Outcome of the ACV working group meeting 6 based on document ACV-06-02

## Proposed amendment to ECE Regulation 13

The text reproduced below was prepared by the experts of the informal working group ACV for the amendment of Regulation No. 13. This is to enable the use of automatic couplings systems.

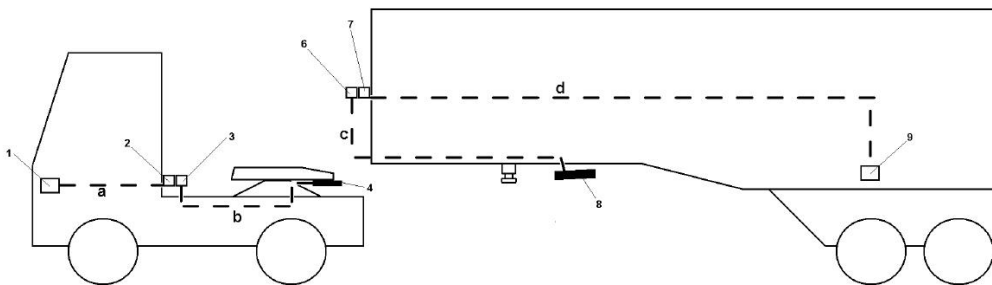
**2.2. Deviating from ISO 11992-1, the maximum permissible cable lengths shall be :**

**Towing vehicle  $l_1$  : 18m**

**Coiled cable  $l_2$  : 0 m**

**Towed vehicle  $l_3$ : 22 m.**

**Figure D: Point-to-point connection ECU Tractor (1) and ECU Trailer (9) when Fifth Wheel is closed**  
**Coiled cables connected, Line 6 to 8 is not connected ??????**

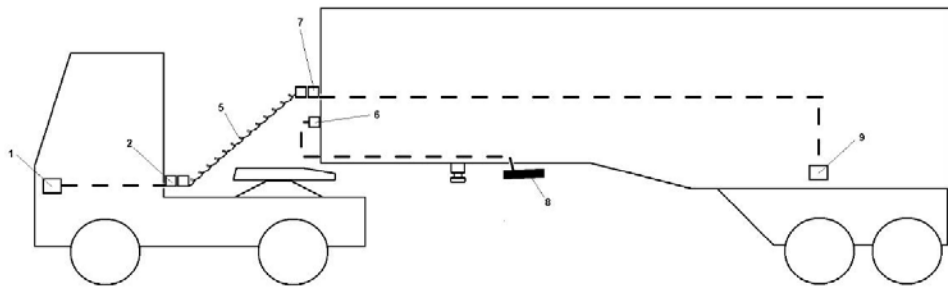
**Manual mode B (only the semi-trailer equipped with automated connection)**
